**EAST GOSHEN TOWNSHIP  
PLANNING COMMISSION  
Meeting Agenda  
Wednesday, January 4, 2023  
7:00 PM**

**Re: Revised Preliminary/Final Plan  
Applebrook Golf Club – Turf Maintenance Area  
East Goshen Township, Chester County, PA**

Re: **Revised Preliminary/Final Plan**  
Applebrook Golf Club – Turf Maintenance Area  
East Goshen Township, Chester County, PA  
CVE Project No. 20558-0015

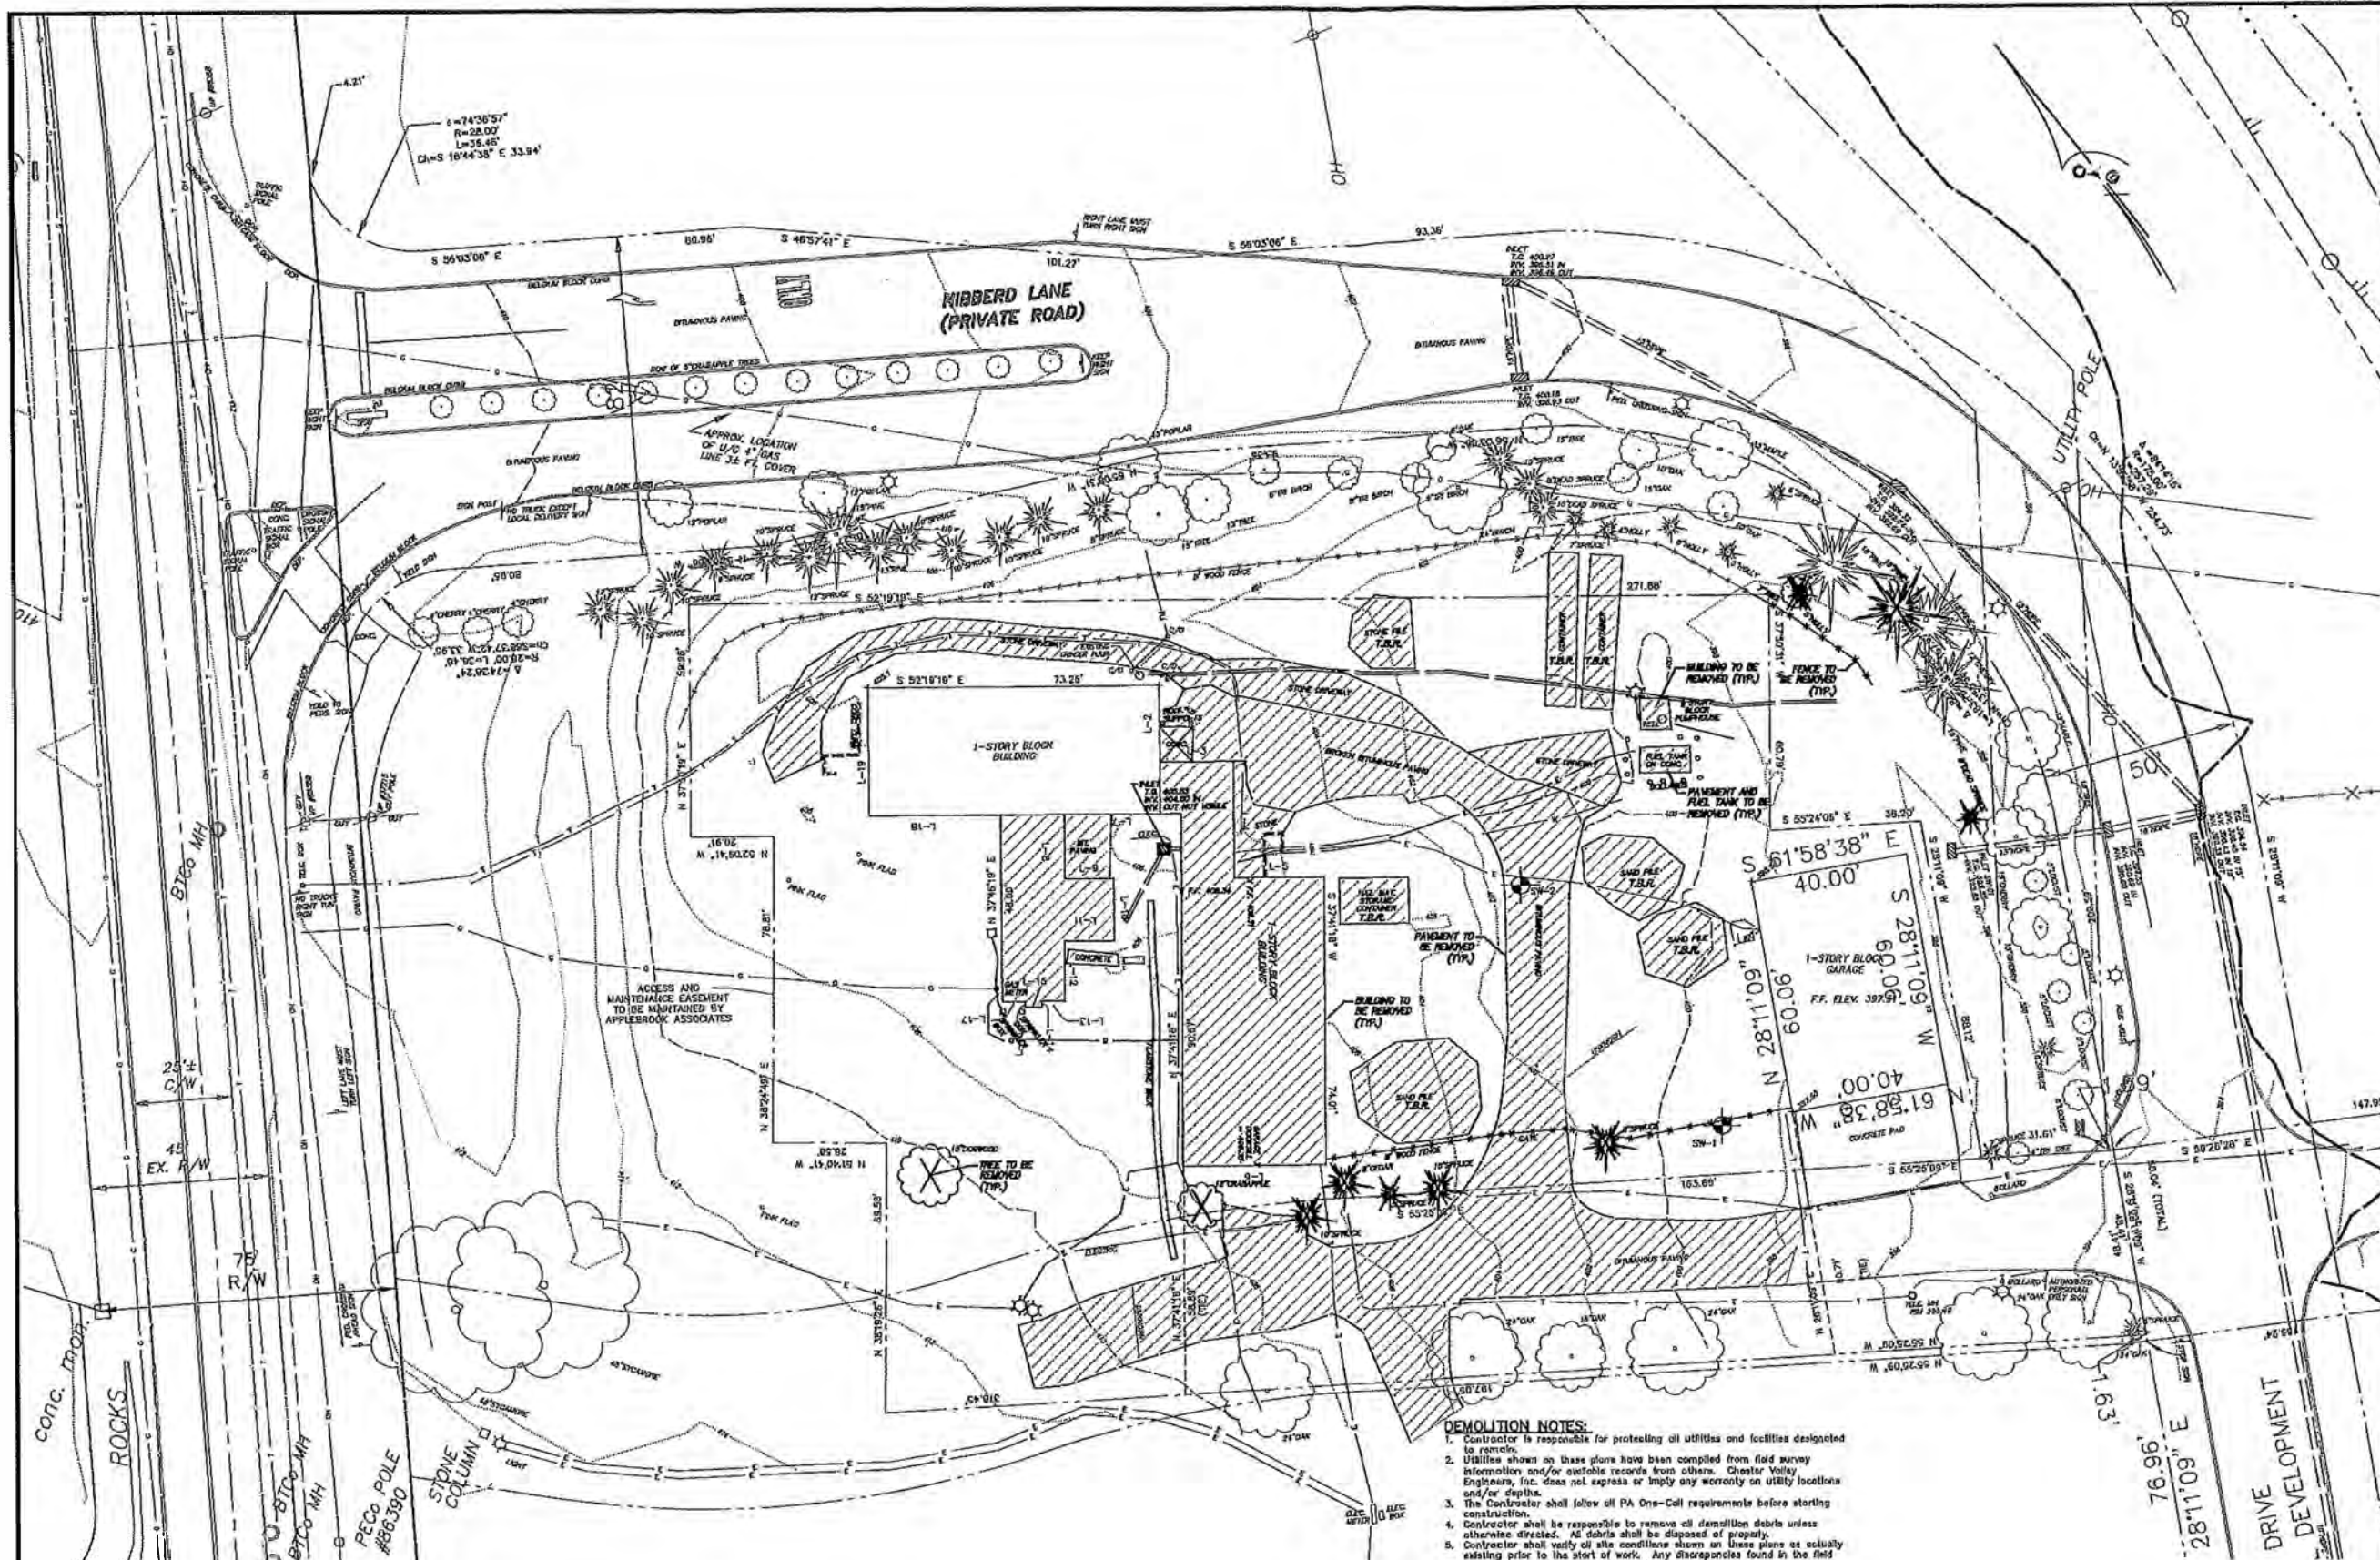
11. Note maintenance buildings for storage and maintenance of equipment directly related to the golf course use may be located off site on property contiguous to the golf course, provided that there is direct access to and from the accessory buildings to the golf course over a private street or driveway serving the golf course and a subdivision plan of the off-site property is approved by the Board of Supervisors. (§340-30.1(C)(1)(g)) No further action is required, but it may be appropriate to include this as a note on the plans.

12. Soil types should be added to the plans. (§205-27.B(10)).

***Resolved. An access note has been added to Sheet 2.***

***Resolved. A note regarding the soil types is located on Sheet 2, General Note 8.***

BOARD ON BOARD FENCE DETAIL  
N.T.S.

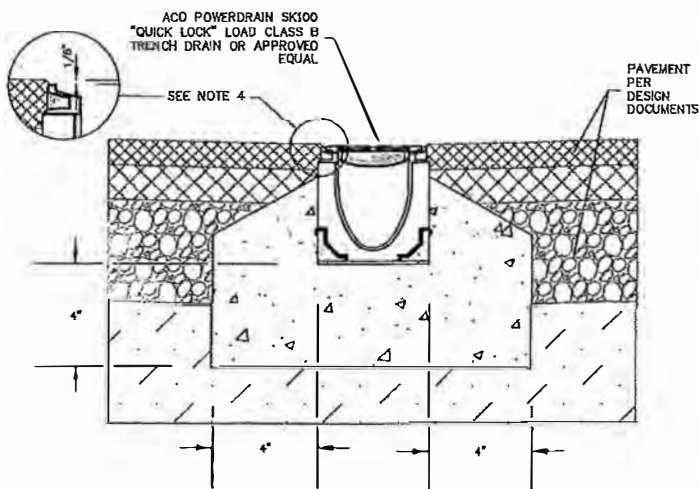
5. All outdoor storage facilities for fuel, raw materials and products stored outdoors shall be enclosed by a fence of a type, construction and size as shall be adequate to protect and conceal the facilities from any adjacent properties. Fencing shall not only encompass the question of safety, but also of screening, and the screening shall preferably be evergreens. All national Occupational Safety and Health Administration (OSHA) regulations shall be met (§240-24.E(2)).

***Resolved. Additional fencing has been added to the southern portion of the lot (Sheet 4). A fence detail has been added to the plans (Sheet 6).***

**A screening fence exists around a portion of the site. This fence will be extended to screen the entire yard area that will not be screened by the buildings. A detail of the fence has been added to the plans.**
